**ZONING MAP CHANGE
STAFF REPORT**

Site Location: 2000 Jacksboro Highway Mapsco: 61M

Request: From: "E" Neighborhood Commercial
To: "PD/E" Planned Development for all uses in "E" Neighborhood Commercial plus car wash, quick lube, and associated maintenance uses as indicated on the site plan; site plan included

SITE PLAN FOR KATIE'S EXPRESS CAR WASH AND LUBE AND TUNE BUILDING
 2000 JACKSBORO HIGHWAY
 FORT WORTH, TEXAS 76114

01 SITE PLAN - FULL SERVICE CAR WASH AND LUBE AND TUNE BUILDING

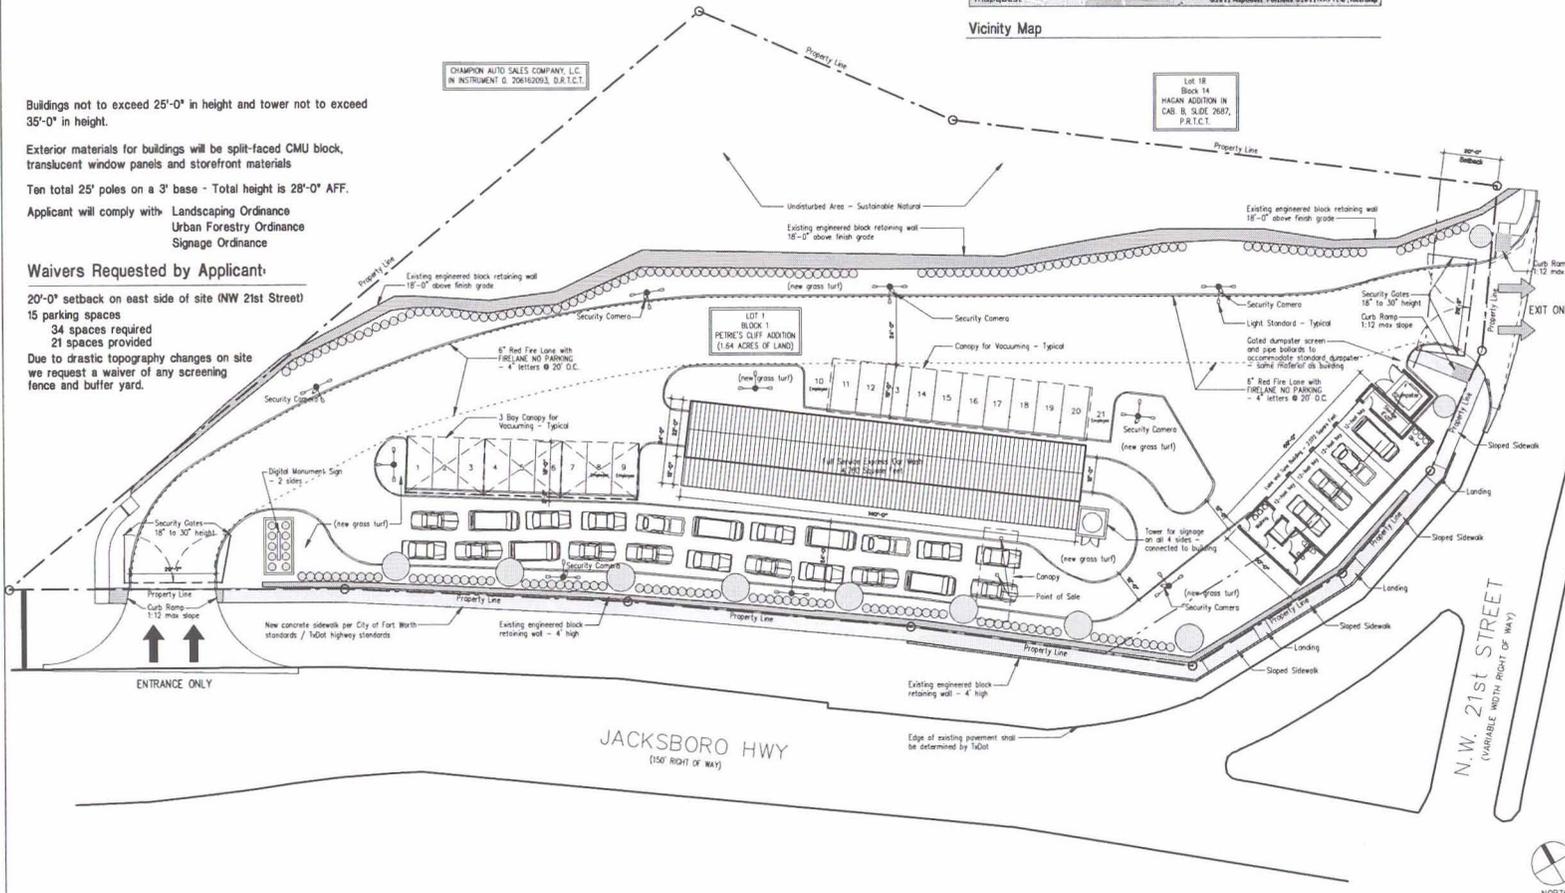
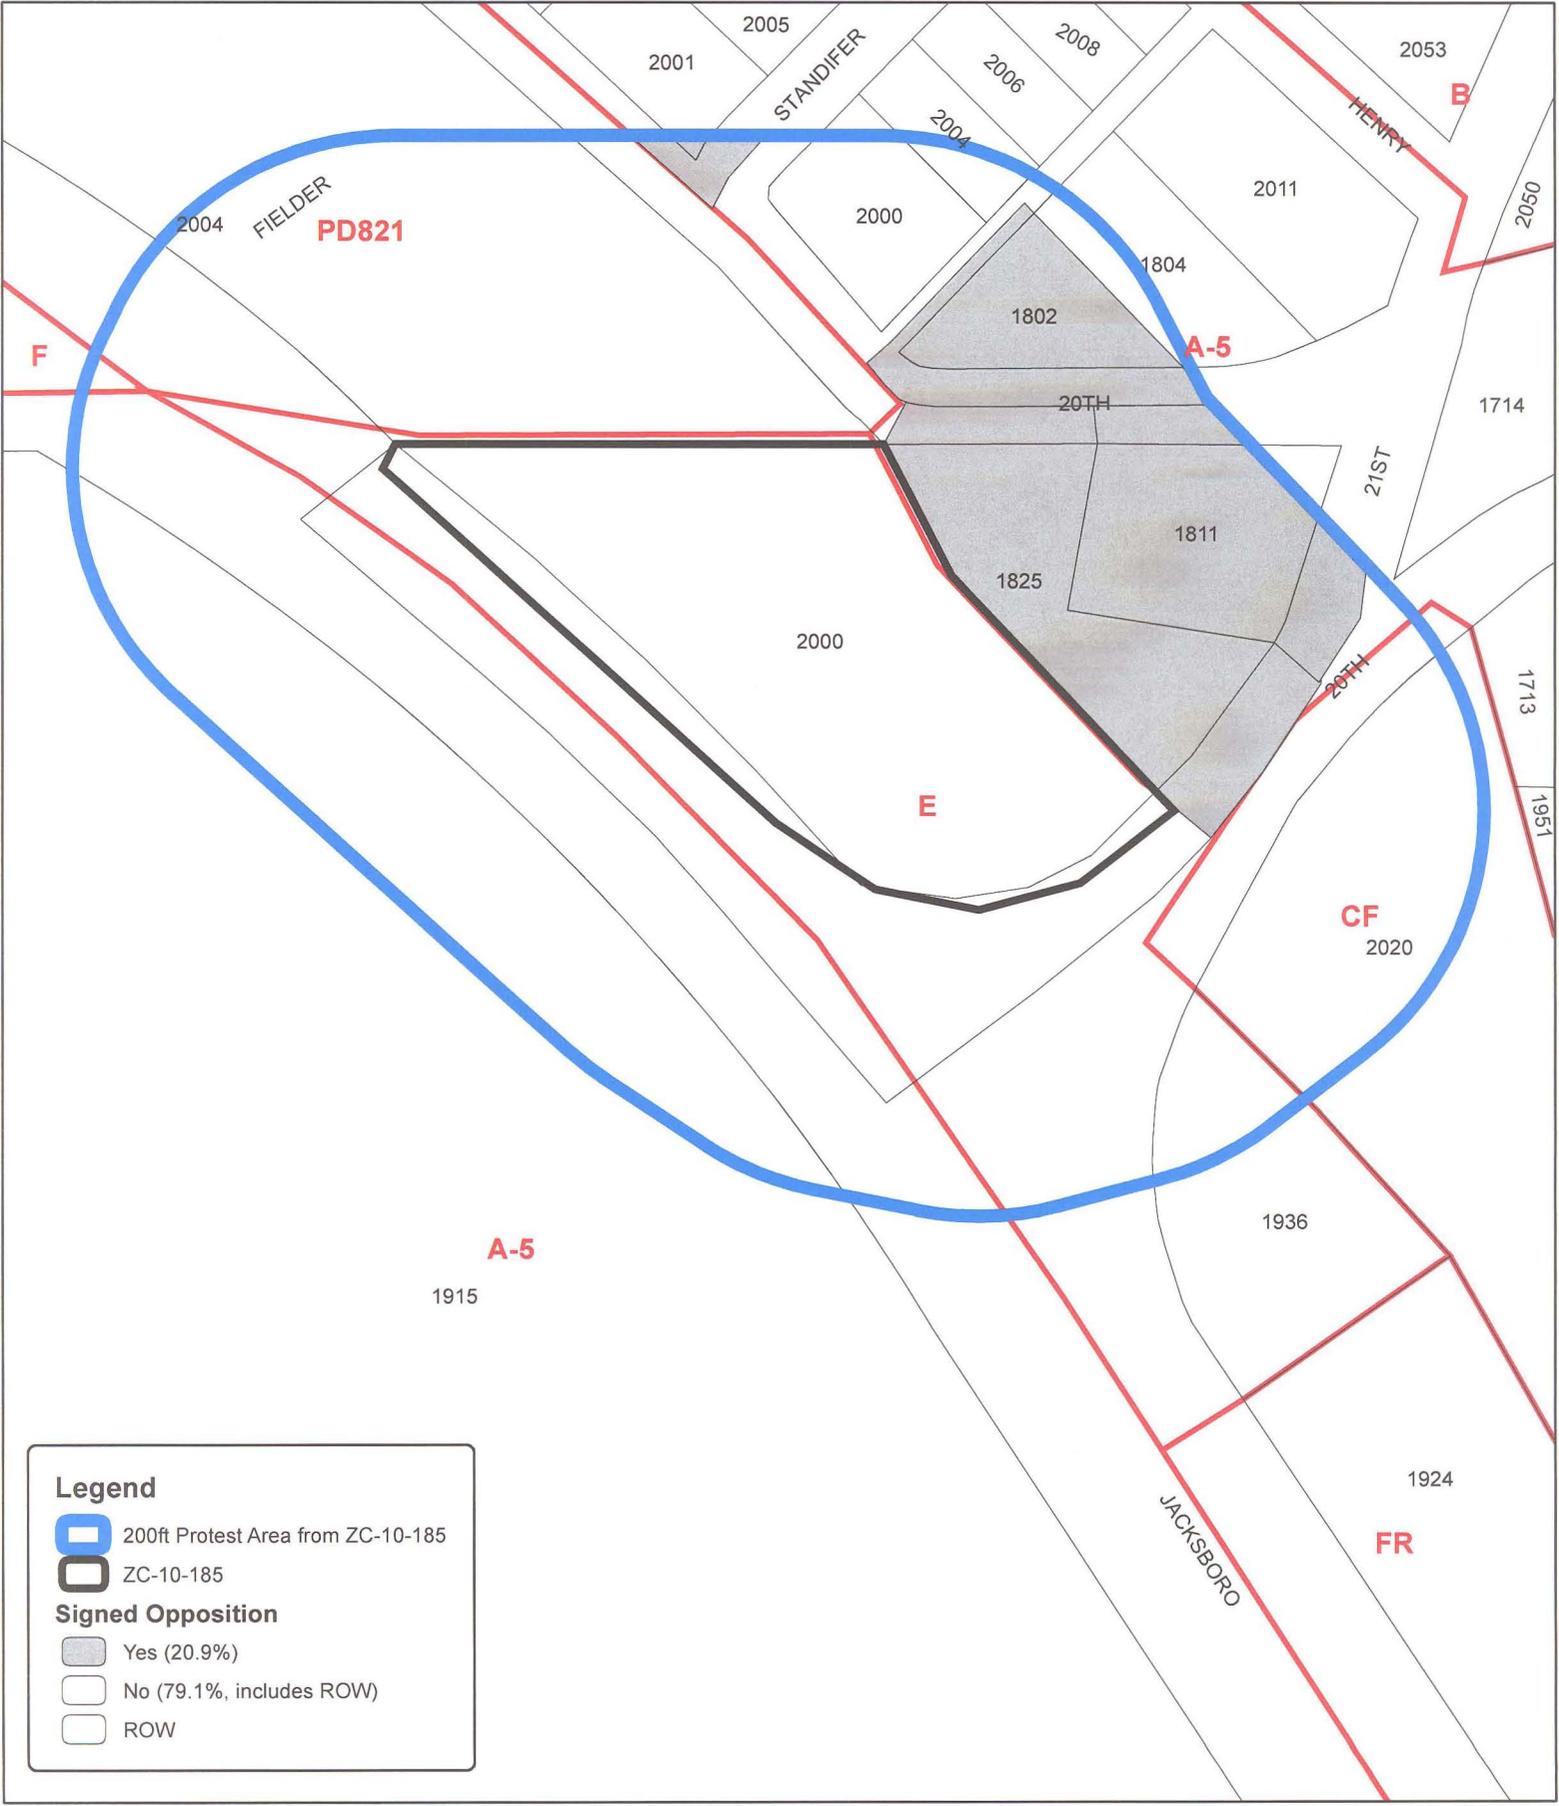
The site plan as submitted is not in general compliance with the Zoning Ordinance regulations. The key deficiencies are:

1. A 20 ft. front yard setback is required along Jacksboro Highway and N.W. 21st Street. (show the location of the 20 ft setback on the site plan (i.e. dotted or dashed line)

- a. Structures (dumpster, signs, auto repair building, gates, and security cameras) are not permitted within the 20 ft. setback.
2. A 20 ft. supplemental setback is required along the rear property line; a portion of the brick retaining wall on the northeast corner encroaches into this setback.

3. There are four parking spaces provided on the site plan for the car wash and auto services. The required parking spaces cannot also be used as a vacuuming area. The car wash would require a minimum of 30 parking spaces and the auto lube a minimum of eight spaces, deficient by 34 spaces.

4. No repairs shall be conducted on any premises that adjoin a residential district boundary.
5. No automobile repair or service facility shall be permitted to have bay doors facing a one or two-family district.

6. A permanent screening fence or wall not less than six feet in height shall be constructed along any site property line which abuts a residential district.

Zoning Commission recommended waivers to the items mentioned above.
